# Addendum 01

**PROJECT:** Fort Recovery Ticket Booth and Referee Building
230 William Street
Fort Recovery, OH 45846

**PROJECT #:** 26070.00

This addendum form is a part of the Contract Documents and modifies the Construction Documents dated October 28, 2026, with amendments and additions noted below.

**BUILDING AND WALL SECTIONS DETAILS**

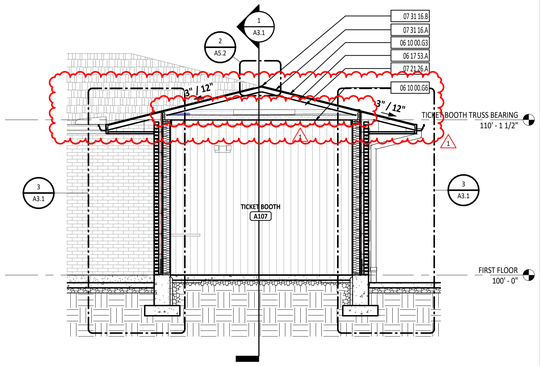
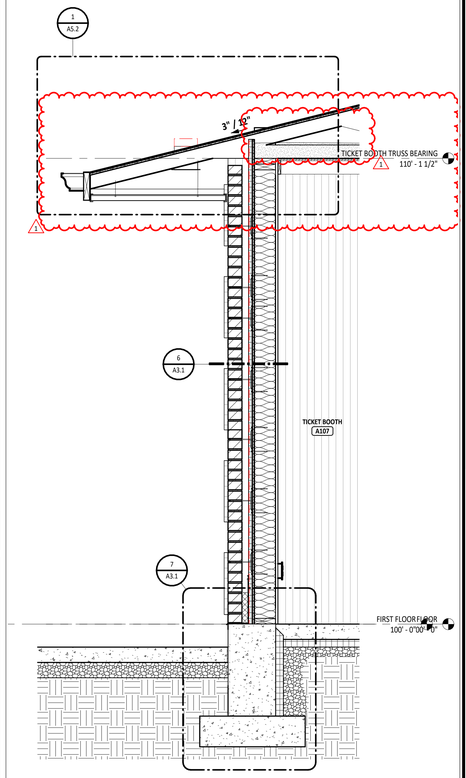
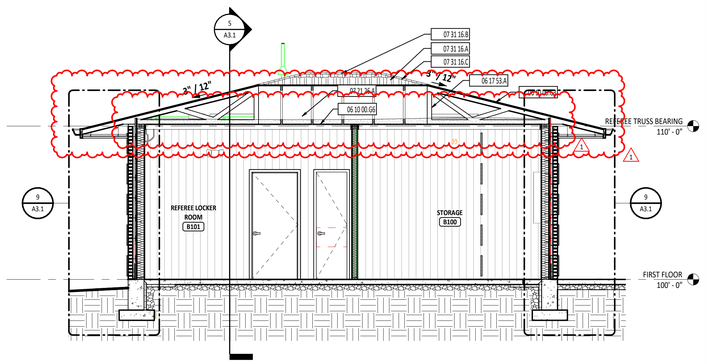
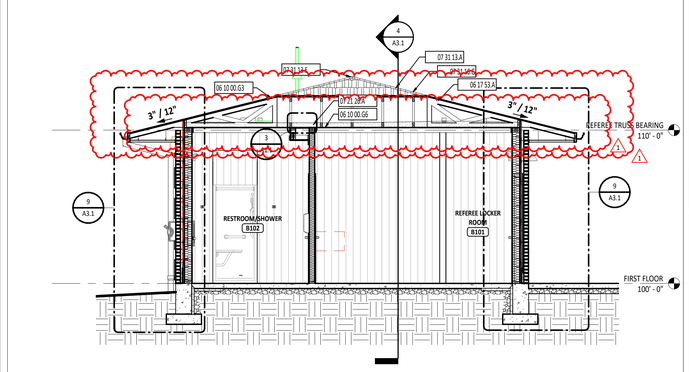
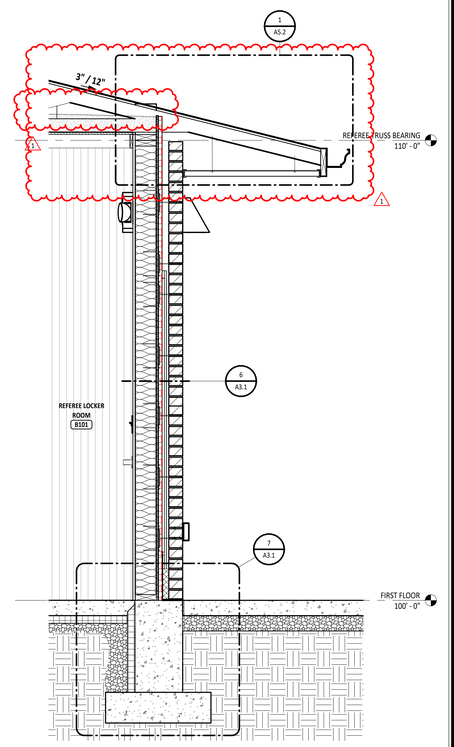
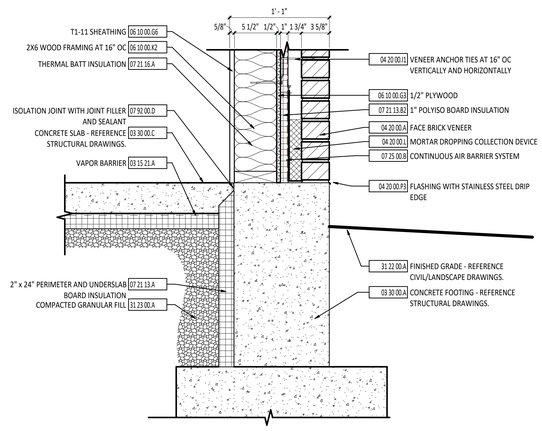
10. Sheet A3.1 – Building and Wall Sections Details
    a. Updated to correct address.
    b. Added 1x trim – painted along ceilings.
    c. Adjusted wall bearing height on referee building to 10'-0" and locker room addition to 10'-1 1/2"

SHEET NUMBER:
**A5.1**

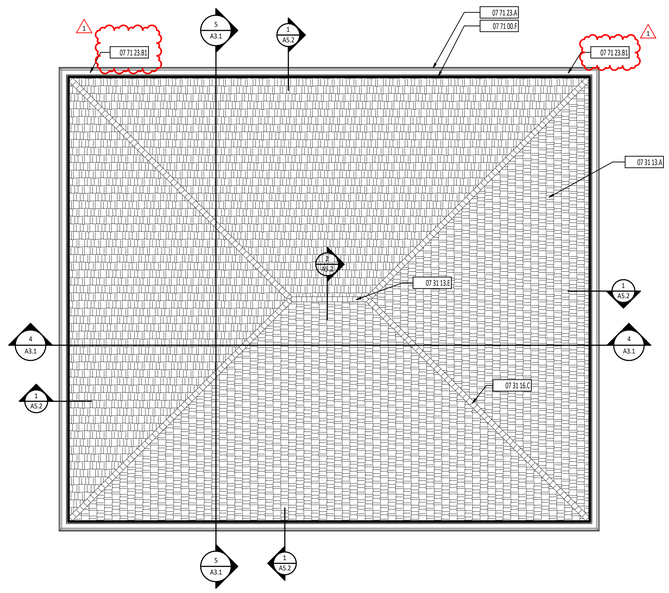
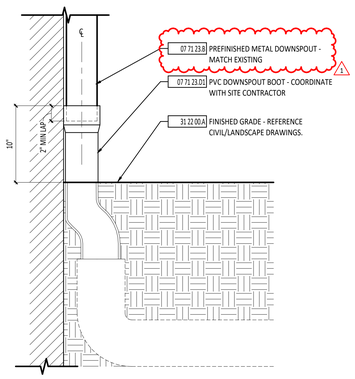
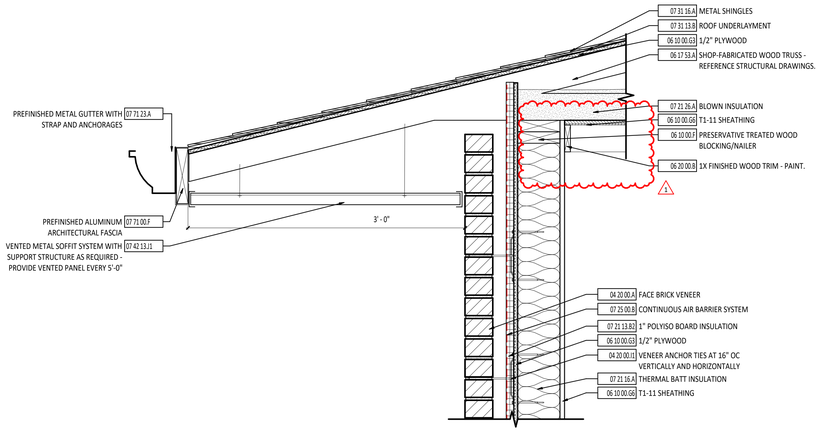
11. Sheet A5.1 – Roof Plan and Details
    a. Updated to correct address.
    b. Updated prefinished downspout keynote description to match existing.
12. Sheet A5.2 – Roof Details

## DOOR SCHEDULE, TYPES AND DETAILS

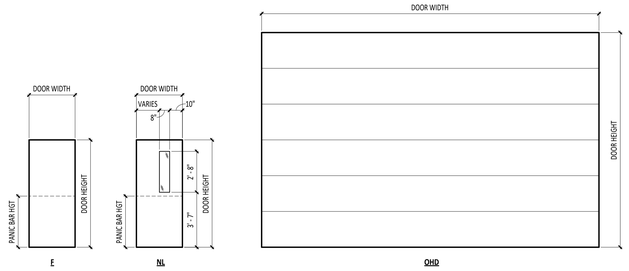
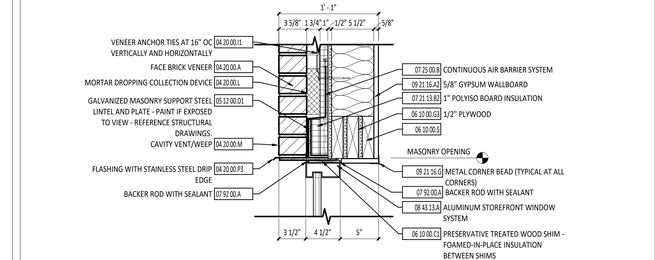
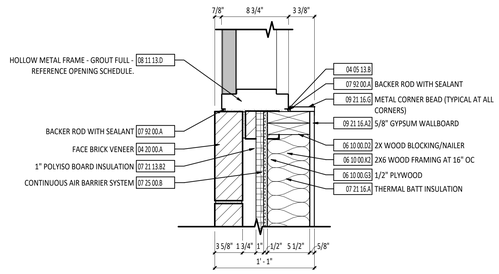
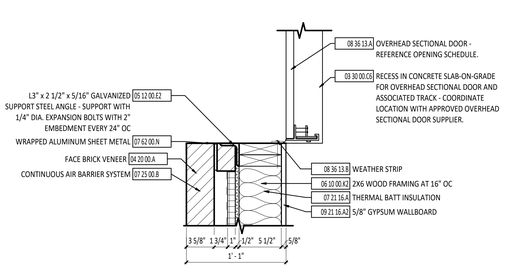
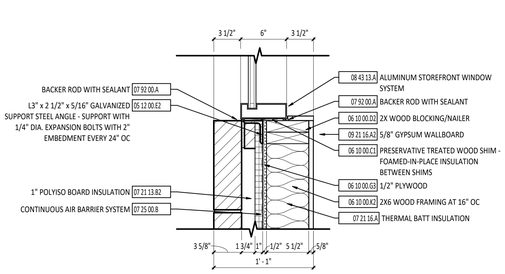
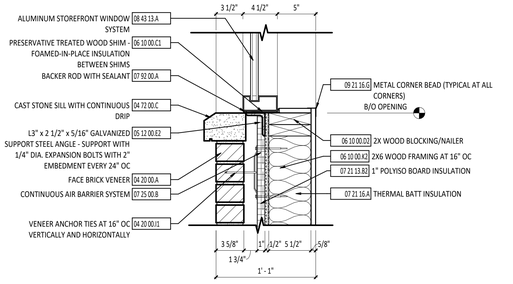
b. Added window detail callouts to window elevation.
